FENCE PERMIT
GRAND JUNCTION COMMUNITY DEVELOPMENT DEPARTMENT

PROPERTY ADDRESS 663 Chama Lane
TAX SCHEDULE NO 2945-038.39.001
PROPERTY OWNER Stan + Pam Scott
OWNER'S PHONE 245-5205
OWNER'S ADDRESS 663 Chama Lane
CONTRACTOR
CONTRACTOR'S PHONE
FENCE MATERIAL Cedar Picket (solid)
FENCE HEIGHT 6'

RE: Valley Meadows East
Home Owners Association
Fencing Revision Request

PLOT PLAN

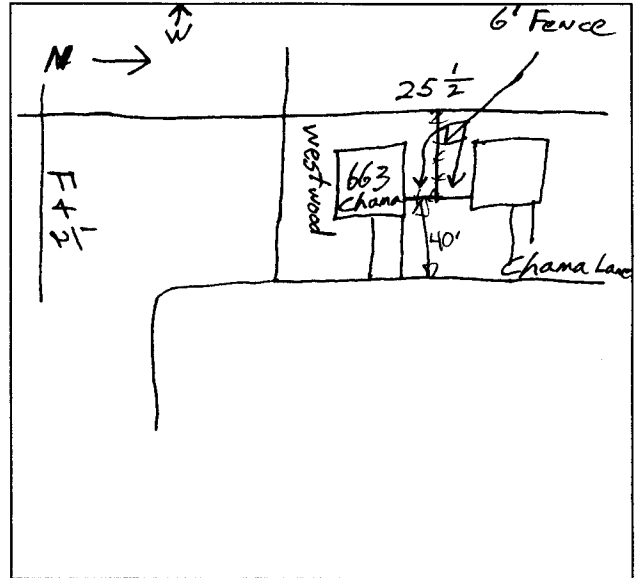
ZONE PR-3.0
SPECIAL CONDITIONS fence abutting 25 1/2 Rd must be 4' in ht for an 8' section.
SETBACKS: Front 20' from property line (PL) or from center of ROW, whichever is greater.
Side from PL Rear from PL
